Docket Number:	08-AFC-08A
Project Title:	Hydrogen Energy Center Application for Certification Amendment
TN #:	200824
Document Title:	Comments to the Department of Energy re the Draft Evironmental Impact Statement and Preliminary Staff Assessment for HECA
Description:	N/A
Filer:	Tiffani Winter
Organization:	Association of Irritated Residents
Submitter Role:	Intervenor
Submission Date:	10/10/2013 2:56:44 PM
Docketed Date:	10/9/2013

Comments to the Department of Energy re the Draft Environmental Impact Statement for Hydrogen Energy California via email: fred.pozzuto@netl.doe.gov and also to the California Energy Commission re the Preliminary Staff Assessment, Docket No. 08-AFC-8A submitted electronically

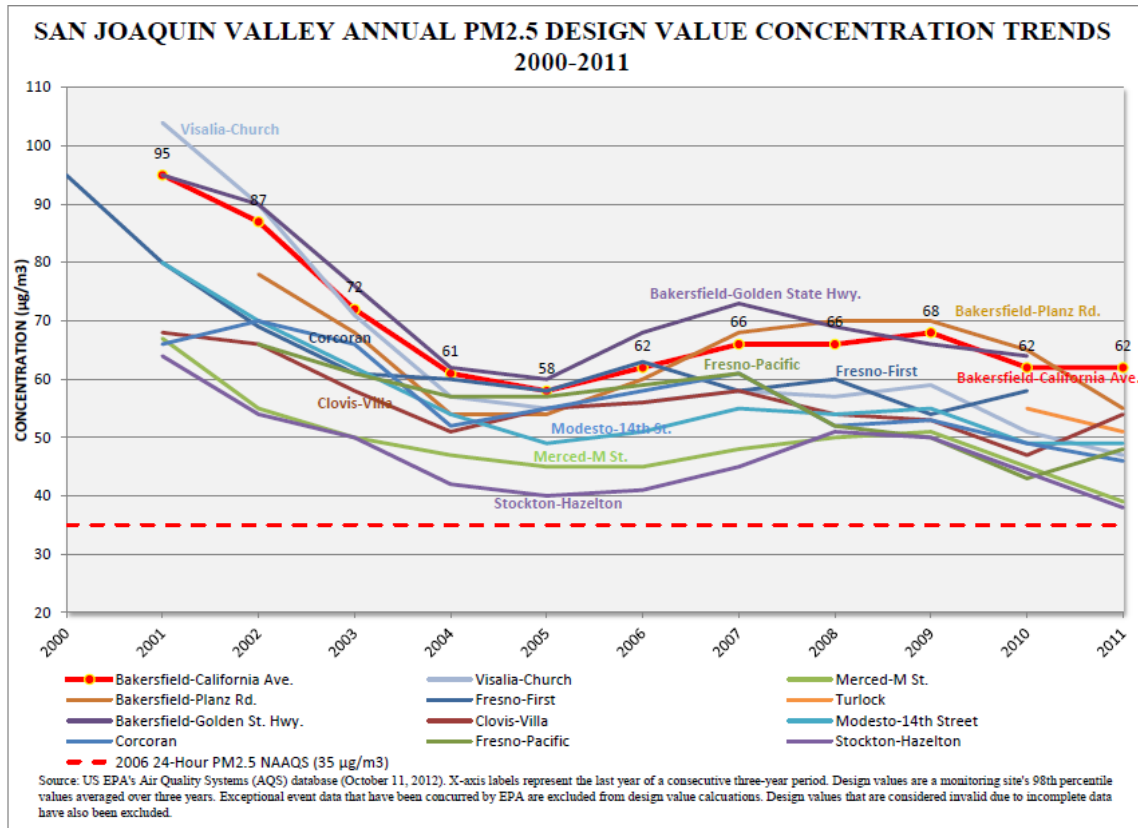
The chart below of PM2.5 Design Values also shows little to no improvement for the Bakersfield-California Ave. monitor since 2005.

ERC use is therefore not justified for the obvious reason that progress in meeting air quality standards has stagnated in recent years and HECA will introduce significant new emissions into the Kern County air basin. The CEC and the DOE can over-rule the SJVAPCD in deciding whether there is reasonable progress in these areas. Please use some logic and actual data as well as looking at the letter of the law in deciding these issues.

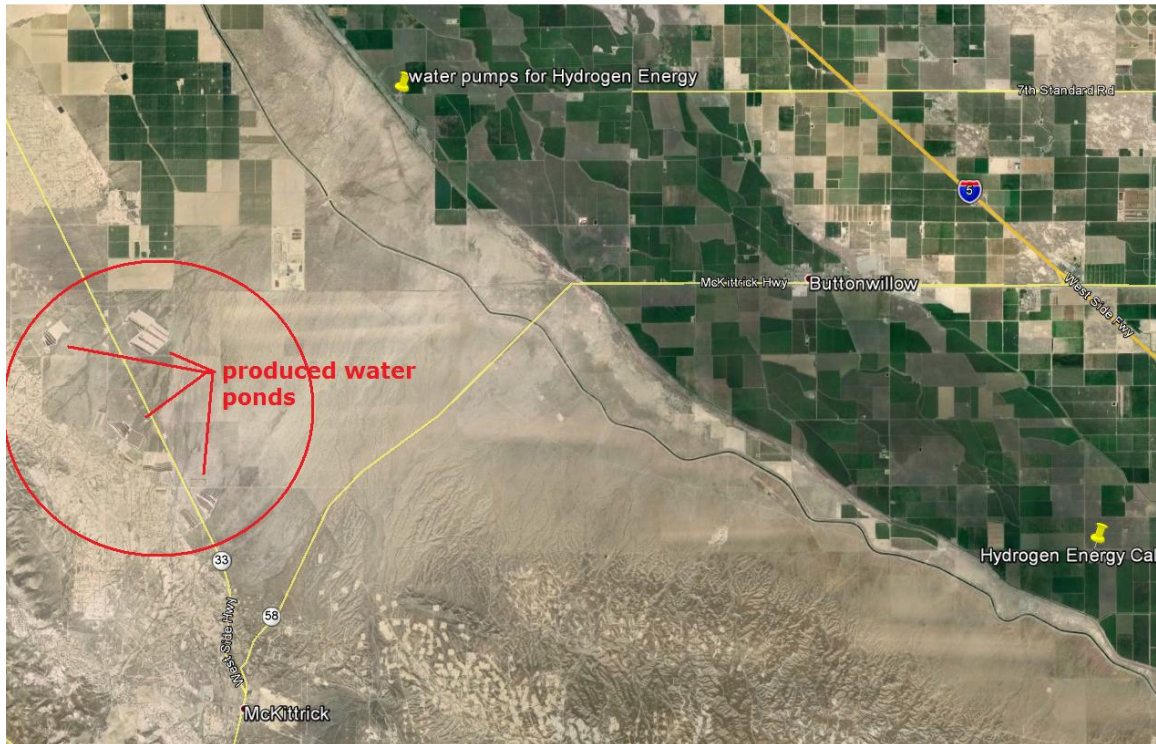
The google earth photo below shows clearly an alternative water source in the evaporation/percolation ponds about 15 miles directly west of the HECA site.

A pipeline could follow Lokern Road and cross the aqueduct above ground and then follow the proposed route for water from the proposed Seventh Standard road and Kern River bed site.

2011 Water Supply Report
Figure 18, Page 62

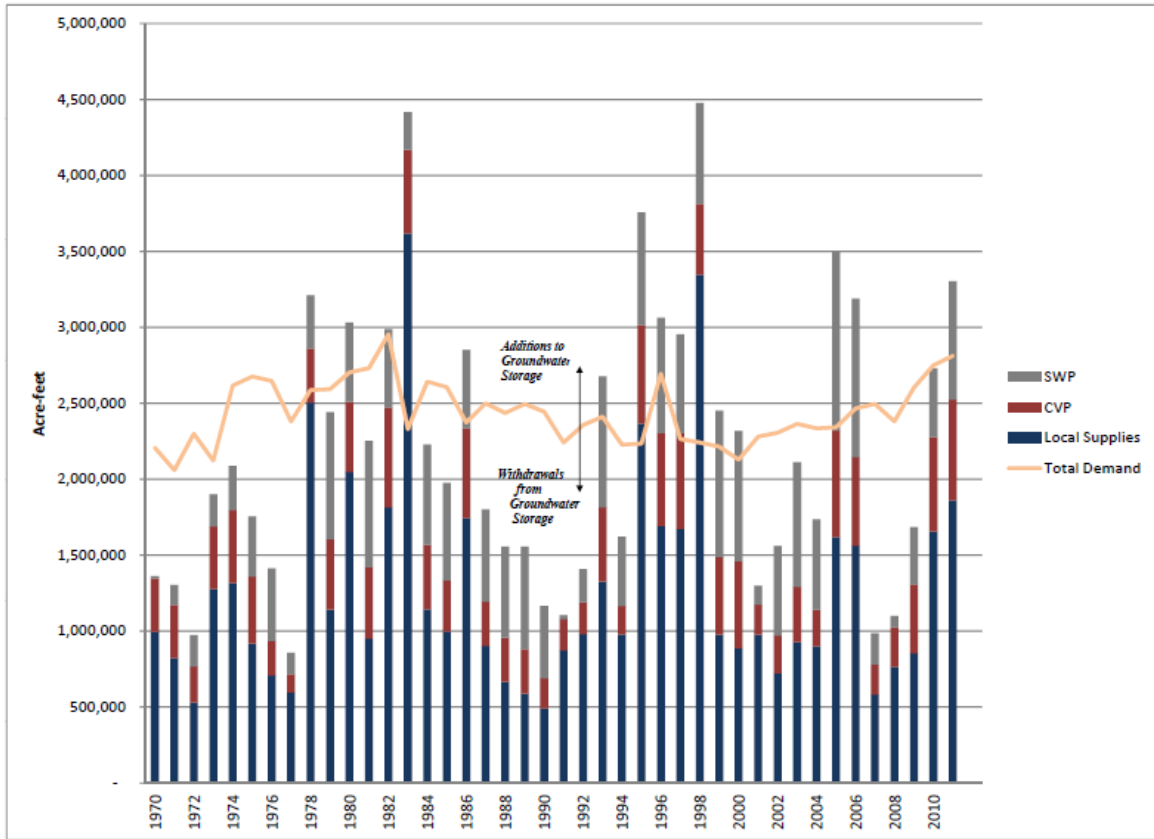
Below is a table of water supply in the Kern groundwater sub-basin from 1970 through 2011 made by the Kern County Water Agency. The analysis of this information shows an annual average groundwater overdraft of approximately 80,000 acre-feet per year over this time period. The cumulative overdraft during this time is 3.4 million acre feet. 2012 and 2013 are significant overdraft years as well.
